**PLANNED UNIT DEVELOPMENT
& SUBDIVISION STAFF REPORT****Date: January 21, 2021****DEVELOPMENT NAME**

Carondolet Subdivision

Planned Unit Development Approval to allow a private street subdivision and multiple buildings on a single building site; and Subdivision approval to create one (1) legal lot of record from one (1) existing legal lot and five (5) metes-and-bounds parcels.

SITE PLAN

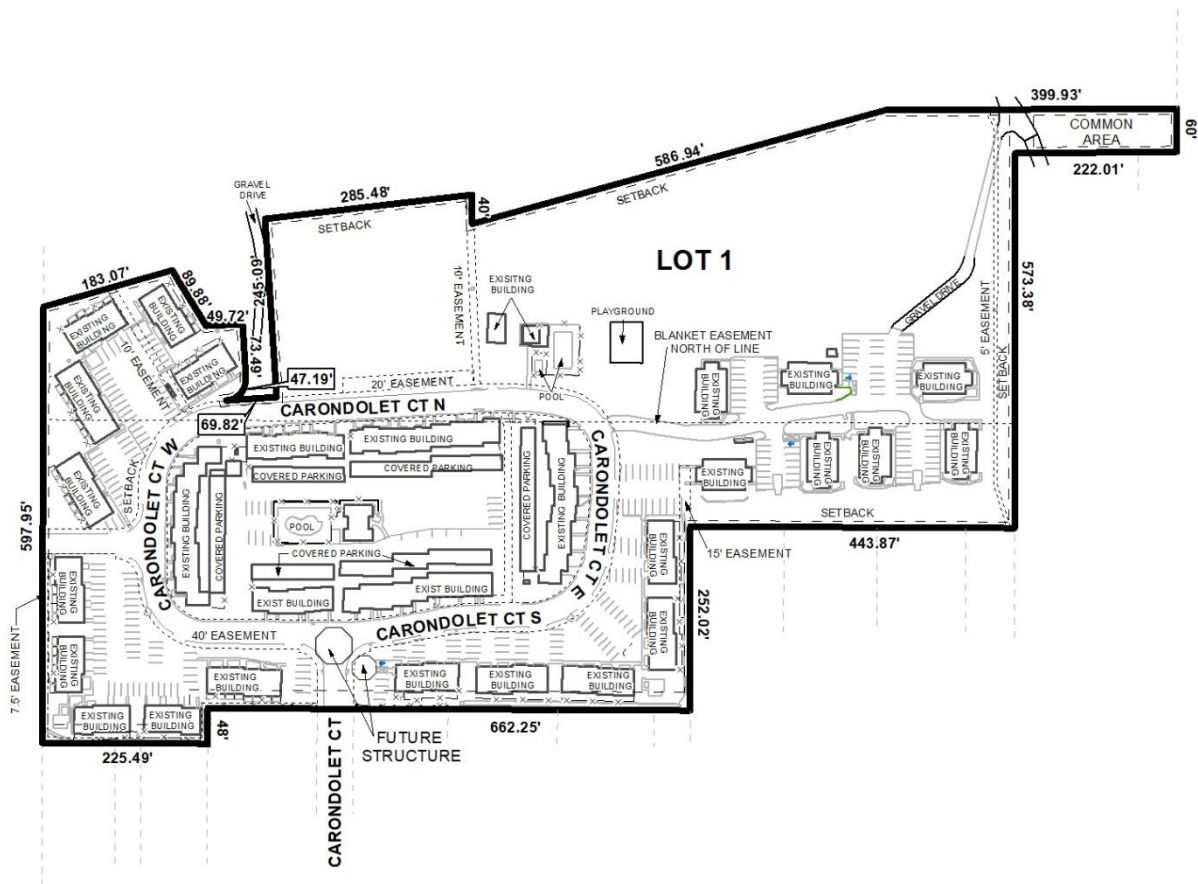
It should be noted that the preliminary plat and site plan both depict building setback lines around the property, however they are not entirely correct. The required 25' minimum front building setback along Carondolet Court is depicted along the entire Southern property line, causing several buildings to encroach into the setback. If approved, the 25' front setback should be revised to be illustrated only where public right-of-way abuts the subject site. Furthermore, all other setbacks along the property boundaries are depicted at eight feet. If approved, this should be revised to either not show side and rear setbacks (as they are not required by the Subdivision Regulations) or reflect a minimum setback of 10' where the site abuts residentially zoned or utilized property and may be a minimum five feet where the site abuts commercially zoned property.

There are two existing dumpsters depicted on the site plan. Any future additional shared dumpsters will need to meet the setback, enclosure and sanitary sewer connection requirements of Section 64-4.D.9. of the Zoning Ordinance and be illustrated on a revised PUD site plan.

The applicant proposes a new leasing office and private gate and both are depicted on the site plan by a bubble labeled “future structure”; however, the specific size, shape, and location of the structures is not depicted. As the proposed areas for the gate and leasing office are illustrated on the PUD site plan, once the street vacation is complete and the Final Plat is recorded, the applicant should submit an Admin PUD for the proposed gate and leasing office to ensure site compliance with queuing, parking, and setback requirements etc.

- 11) Provision of two (2) revised PUD Site Plans to the Planning & Zoning Department prior to signing of the Final Plat; and
 - 12) Compliance with all other applicable municipal Codes and Ordinances.

- 5) Provision of two (2) revised PUD Site Plans to the Planning & Zoning Department prior to signing of the Final Plat;
- 6) Submittal and approval of an Admin PUD application for the proposed future gate and leasing office; and
